Point Beach Nuclear Plant, Unit 1  
Docket 50-266  
License No. DPR-24  
NRC Order EA-03-009 Relaxation Request Supplement 2

### RESPONSE TO REQUEST FOR ADDITIONAL INFORMATION NRC ORDER EA-03-009 RELAXATION REQUEST SUPPLEMENT 2

#### POINT BEACH NUCLEAR PLANT, UNIT 1

Figure 6-5

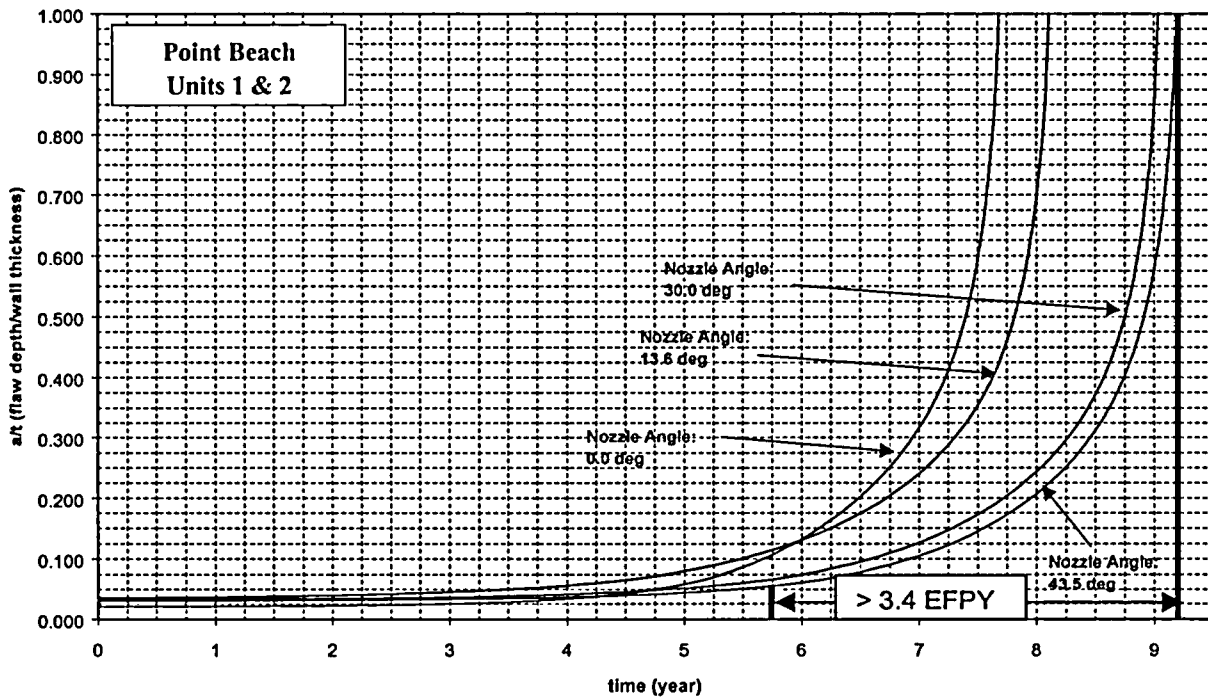
Figure 6-5 of WCAP-14000 is reproduced below. This figure represents a crack growth prediction for axial inside surface flaws near the attachment weld on the downhill side. The 43.5° curve is used. The flaw aspect ratio is 6:1. For an initial a/t value of 0.06, a flaw would require over 3.4 EFPY to reach a through-pressure boundary of 1.0 a/t.

**Figure 6-7**

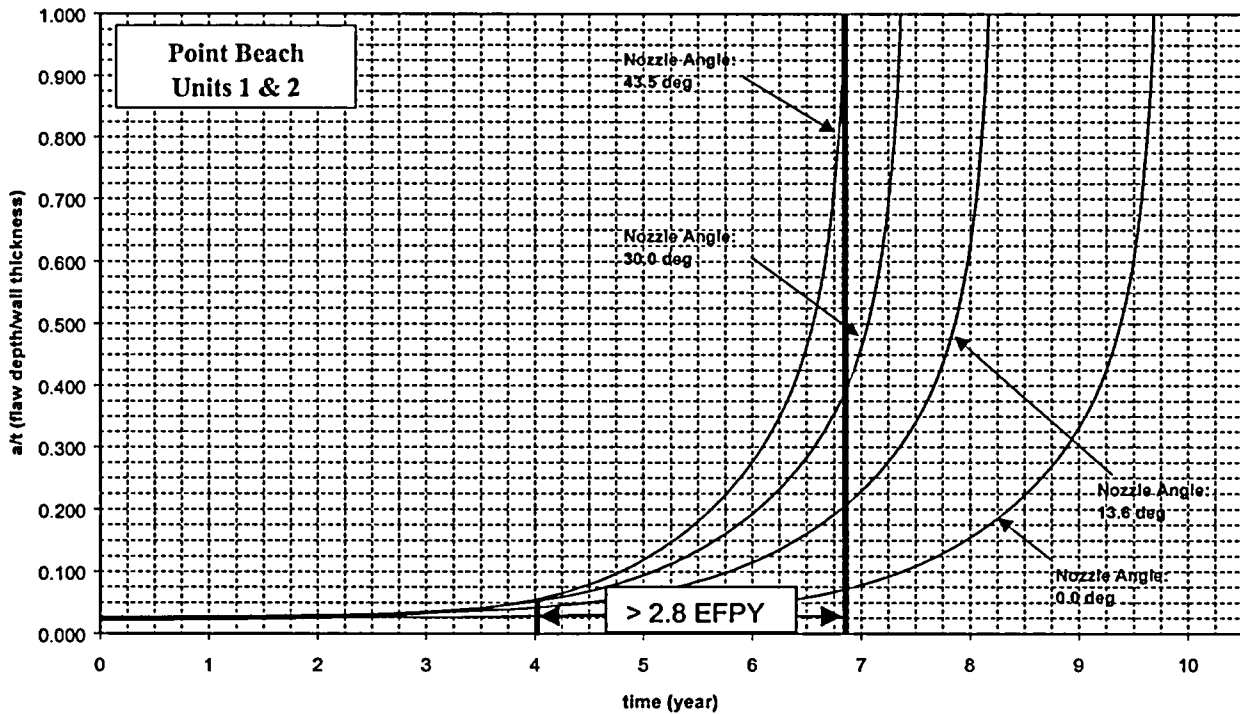
Figure 6-7 of WCAP-14000 is reproduced below. This figure represents a crack growth prediction for axial inside surface flaws above the attachment weld on the downhill side. The 43.5° curve is used. For an initial a/t value of 0.06, a flaw would require over 2.8 EFPY to reach a through-pressure boundary of 1.0 a/t.

PBNP operates on an 18-month cycle and will be replacing the RPV head during the next refueling outage scheduled for fall 2005. Unit 1 operation following the fall 2002 refueling outage (initiation time of the postulated flaw) and the replacement of the RPV head will not exceed 2.8 EFPY. Therefore, a worst-case flaw could not progress through-wall during the next Unit 1 operating cycle.

Figure 6-13

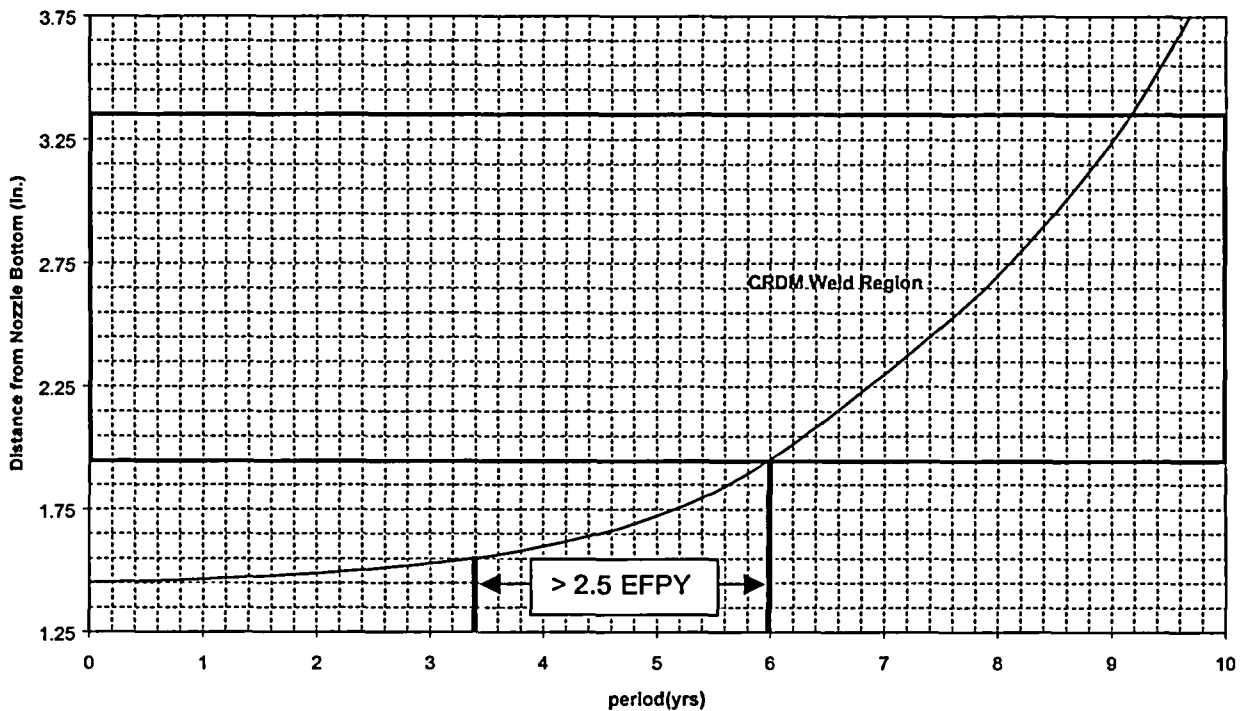
Figure 6-13 of WCAP-14000, shown below, is a crack growth prediction for through-wall axial flaws located in the 30.0° penetration ring. Nozzle 20 is the limiting nozzle for this assessment and is also located in the 30.0° penetration ring. As shown below, the assumed through-wall flaw would take over 2.5 EFY to reach the J-groove weld.

PBNP operates on an 18-month cycle and will be replacing the RPV head during the next refueling outage scheduled for fall 2005. Therefore, a worst-case flaw could not progress sufficiently to reach the J-groove weld during the next Unit 1 operating cycle. Thus, the values used in our calculation are considered appropriate and conservative.
